RE: presentation requested by Panel for DEP project - SSD 8194

Some Comments on the Dendrobium Extension Proposal

IPCN Presentation, December 2nd 2020.

Drainage zone heights wrt depth of cover (DoC) for proposed LW widths in Areas 5 and 6

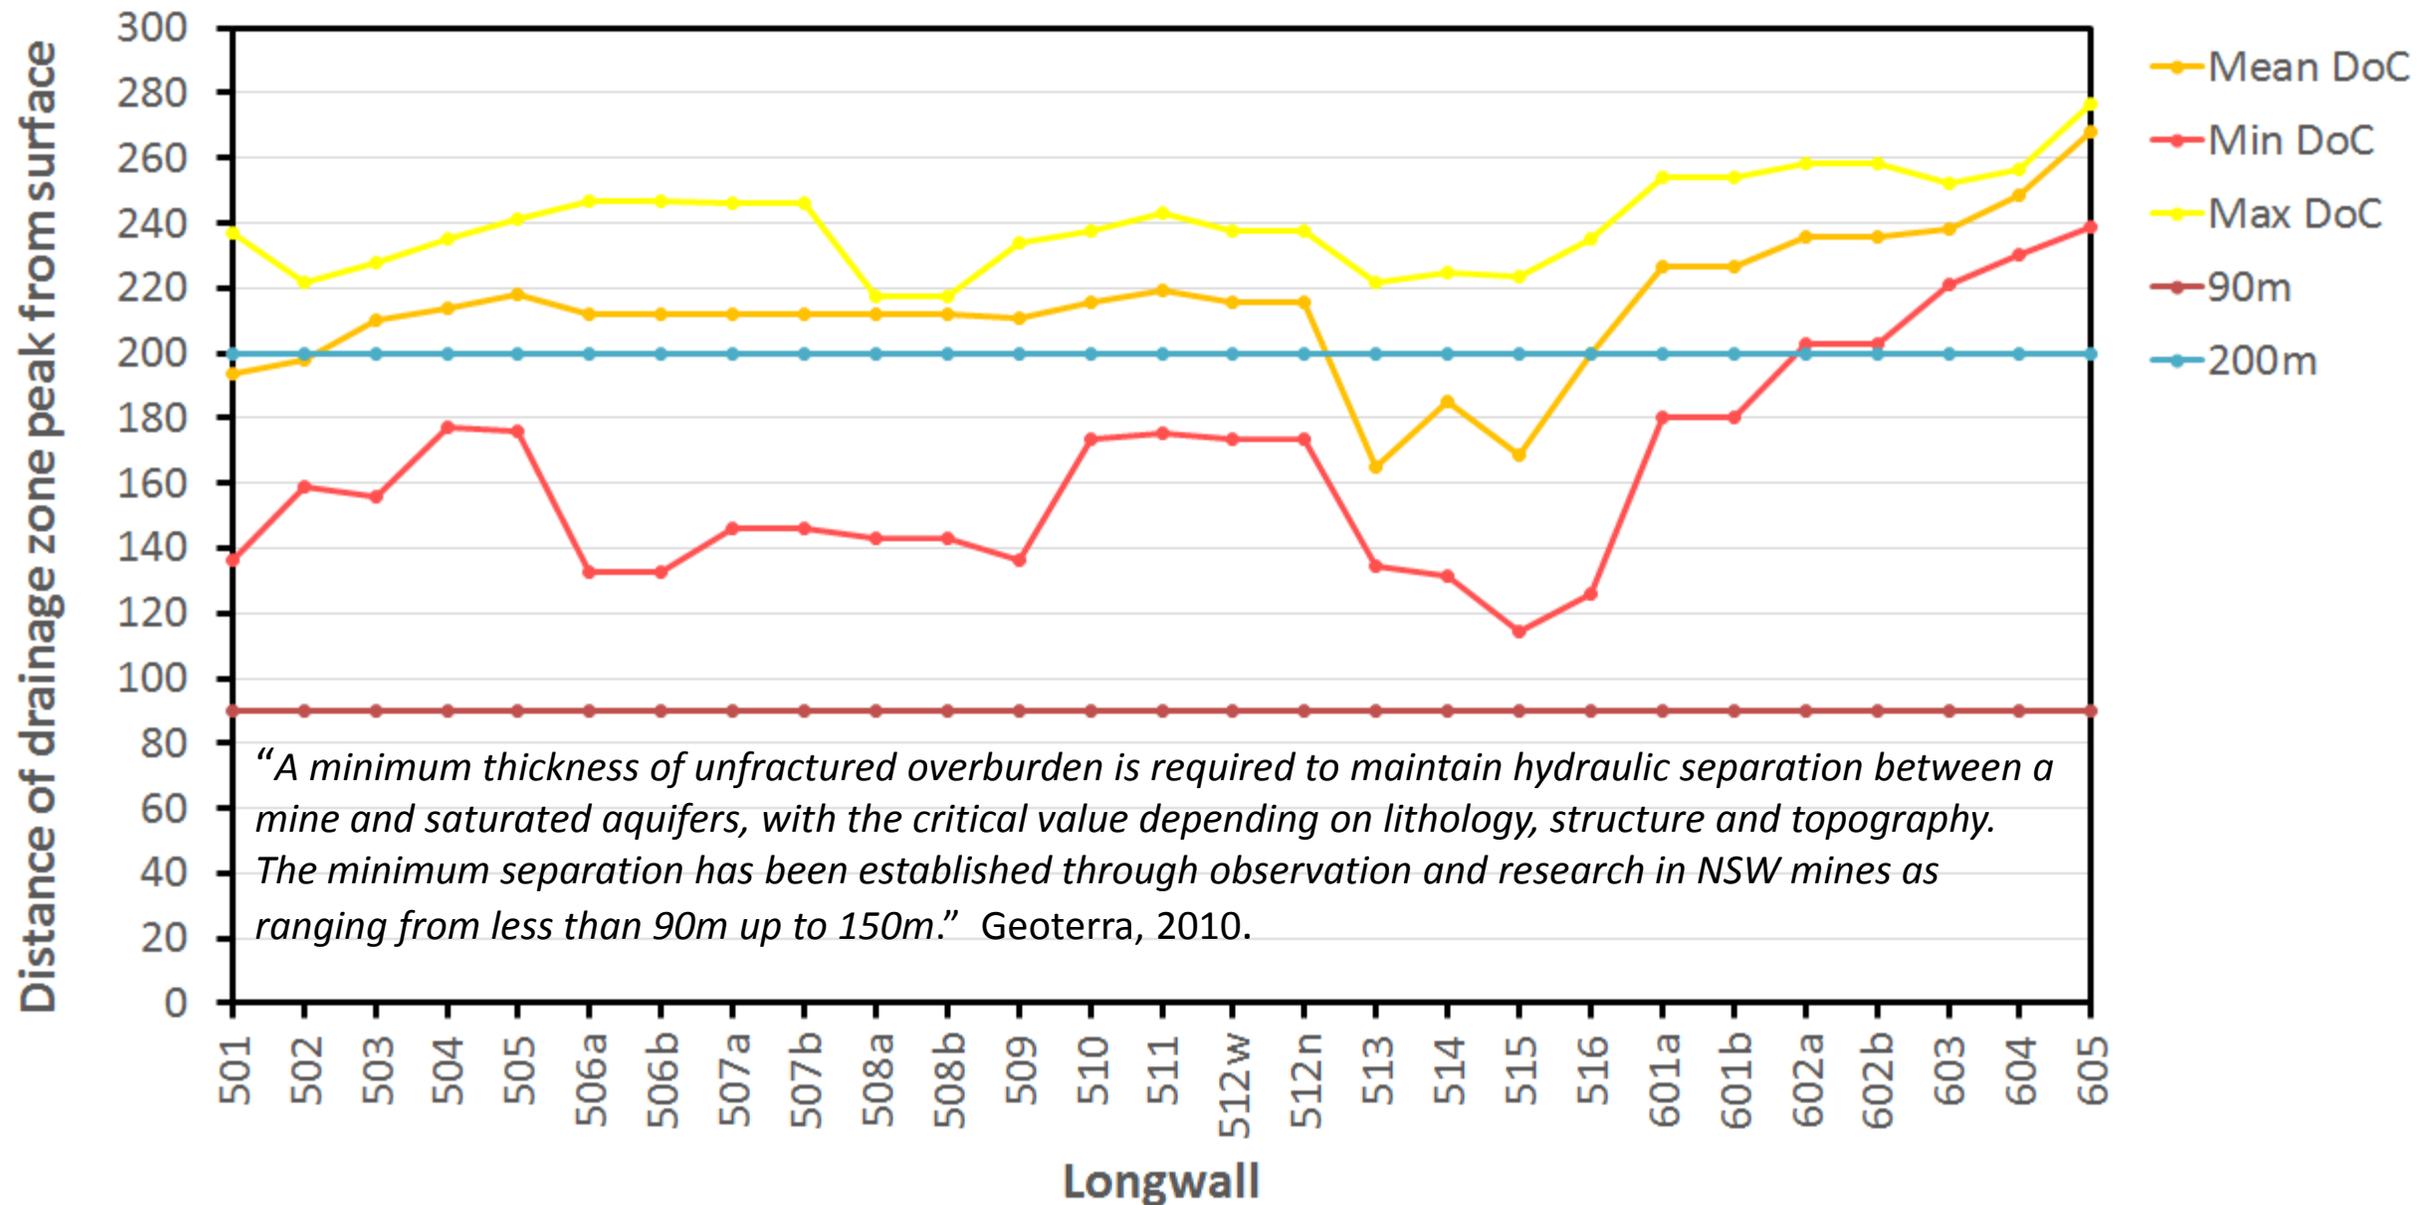
- No recognition in the proposal or DoP assessment that conventional subsidence, which is extraction width sensitive, **compounds** the impacts and consequences of non-conventional subsidence, and vice versa. **Conventional subsidence impacts of 305m panels would be significantly greater than 150m.**

- Lack of recognition that the higher the drainage zone (zone of hydraulically connected fractures) the greater the spread and rate of upper strata depressurisation. This reflects horizontal conductivities being 10 to 1000 times vertical.

Drainage zone heights wrt depth of cover (DoC) for 150m LWs in Areas 5 and 6

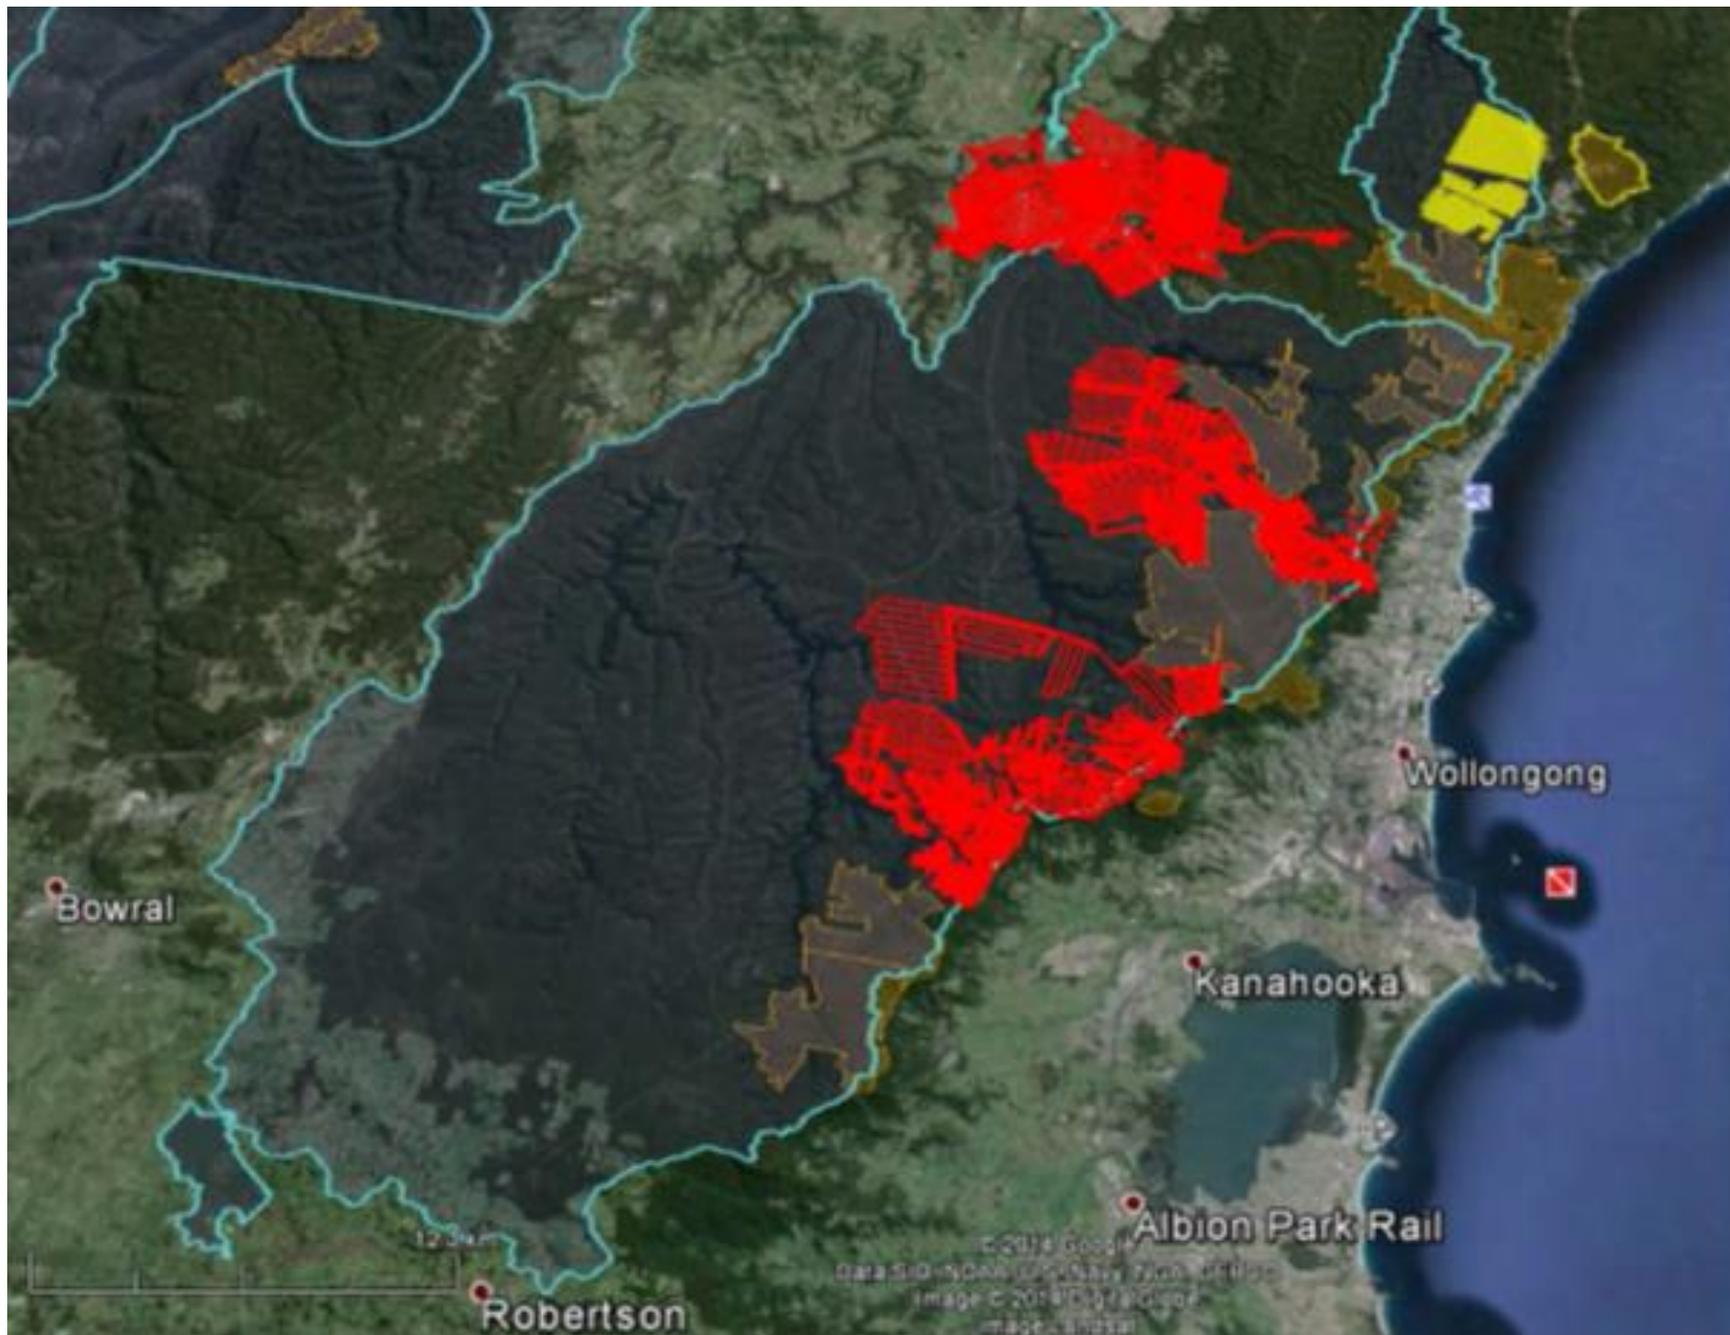
- **Unsupported** implicit assumption that all watercourses in the project area are in sufficiently steep valleys/gorges and/or high horizontal stress fields, that non-conventional subsidence would render differences in the conventional subsidence impacts (and consequences) between 150 and 305 metre extractions irrelevant. **This would appear to be physically implausible.** The proposal doesn't comparatively assess the impacts and consequences of 150m panels.

Fig. 1 Depiction of naturally occurring valley closure from a 2007 report by consultants MSEC.[1] Underground mining accelerates and compounds the natural process, with additional void creation, shearing and fracturing that can extend outward from the valley by tens of metres.

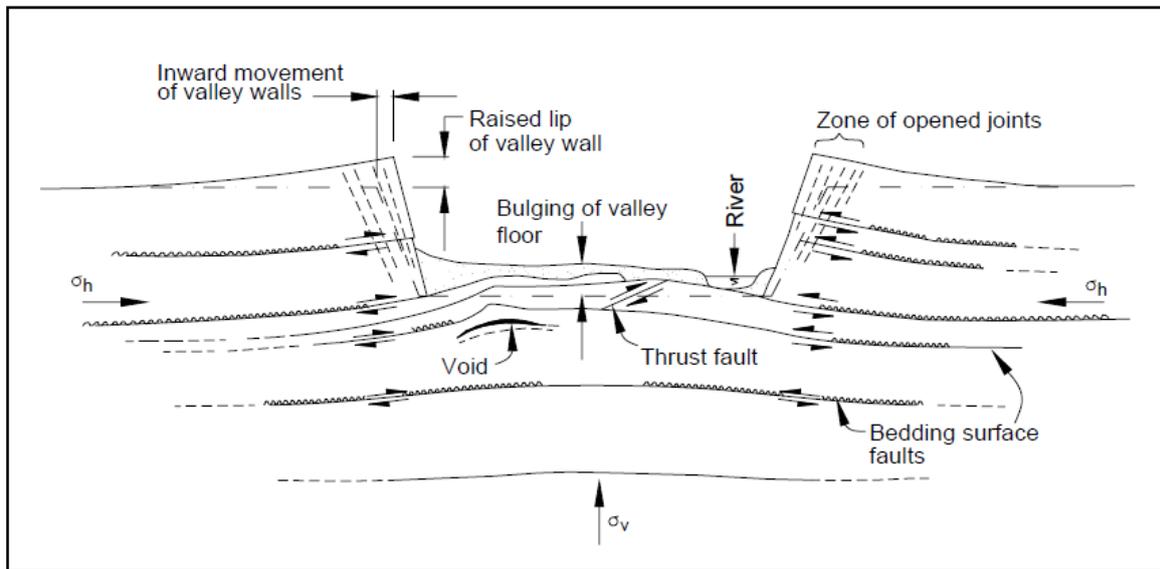
Depicted in Fig. 1 below, valley bulging is a natural process that mining impacts can accelerate and compound.[1] In discussing mining induced ground deformation in valleys and gorges, Section 10.4.4.4 in Prof. Jim Galvin's 2016 textbook[2] on coal mine engineering includes the following observations:

Fig. 2. Depiction of mining induced valley closure and upsidence from Mills.[4] Upsidence typically occurs in a relatively thin band of rock, some 6 to 12 metres, within a 20-30m wide corridor in the centre of the impacted valley.

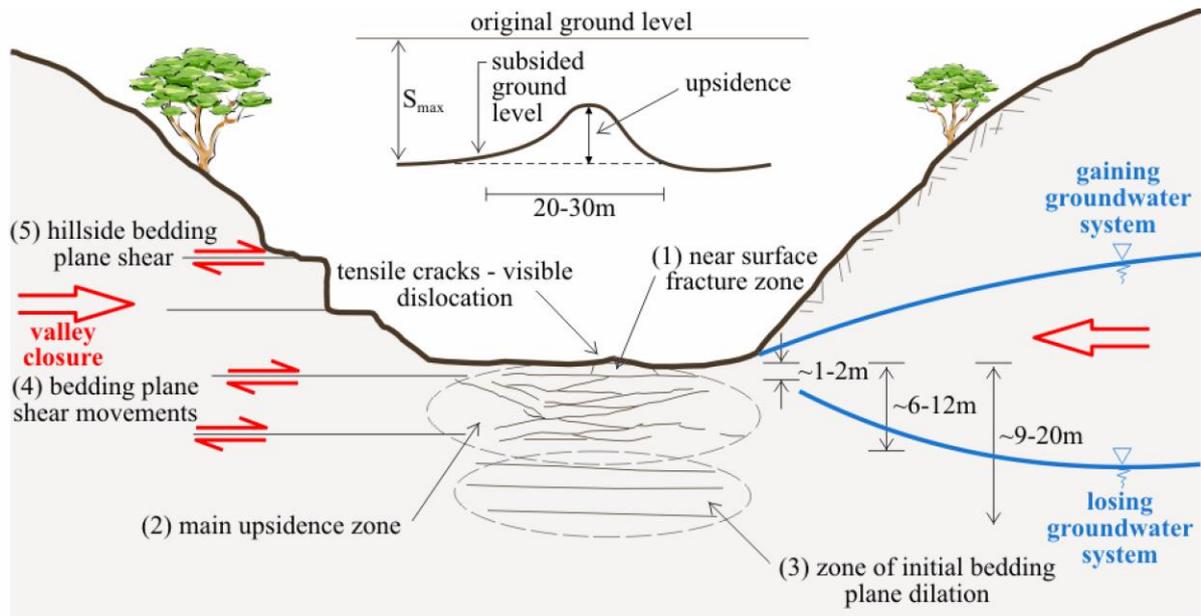
“The main upsidence zone typically occurs within a 20-30m wide corridor where most of the differential horizontal movements and resulting vertical dilation is concentrated. The fractures in this zone develop progressively downward with increasing subsidence, usually to a final depth of about 6-12m below the surface.”

Mining induced upsidence typically occurs in a relatively thin surface zone in the central part of a valley/gorge (see Figs. 1 and 2) and dissipates compressive energy associated with valley closure and, depending on the location of the extraction(s). Conceivably valley closure and horizontal stress could delay the subsidence or upsidence of a narrow band of near surface rock that doesn't yield soon after the onset of subsidence over the void. I'm not aware of any reports that find this to have occurred and, it did occur, it would only delay the failure process.
